Access Compliance Report

Public Rights-of-Way

(Curb Ramps)

Intersection ID: 18408	Main Street: REDCOAT_DR	Cross Street: LYNBROOK_DR	Location: SW
ADA ID: 32581AC9F950	Ramp Type: PerpDiag	Initial Pass/Fail: Fail	Overall Compliance: No
Severity Score: 12.5			
Codes/Mitigation Info/Possible Solution		Field Measurements/Component Compliance

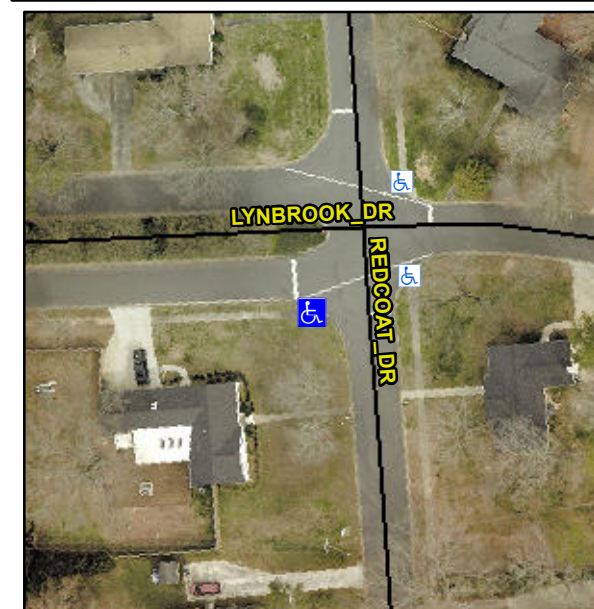
Not Found, R304.2.2

Compliance	Description	Data	Compliance	Description	Data
N/A	Ramp Length (in)	32.0	No	Ramp Slope (%)	8.5
Yes	Ramp Width (in)	48.0	Yes	Ramp XSlope (%)	0.2
N/A	Flare Type LT	N/A	N/A	Flare Type RT	N/A
N/A	Flare Slope LT (%)	N/A	N/A	Flare Slope RT (%)	N/A
N/A	Flare Traversable LT?	N/A	N/A	Flare Traversable RT?	N/A
N/A	Landing Length (in)	N/A	N/A	DWS Provided?	N/A
N/A	Landing Width (in)	N/A	N/A	DWS Contrast?	N/A
N/A	Landing Slope (%)	N/A	N/A	DWS Length (in)	N/A
N/A	Landing X Slope (%)	N/A	N/A	DWS Full Width?	N/A
N/A	Landing Curb? (Y/N)	N/A	N/A	DWS Offset (in)	N/A
N/A	Shared Landing?	N/A			
N/A	Gutter Ponding?	N/A	N/A	Gutter Slope (%)	N/A
N/A	Gutter Lip Ht (in)	N/A	N/A	Gutter X Slope (%)	N/A
N/A	Painted X Walk1?	No	N/A	Painted X Walk2?	No
	X Walk 1 Direction	To E		X Walk 2 Direction	To N
N/A	X Walk 1 Width (in)	N/A	N/A	X Walk 2 Width (in)	N/A
	X Walk 1 Slope (%)	2.6		X Walk 2 Slope (%)	3.6
	X Walk 1 X Slope (%)	4.1		X Walk 2 X Slope (%)	2.3

Remove & Replace Curb Ramp With Two New Directional Ramps or Equivalent.
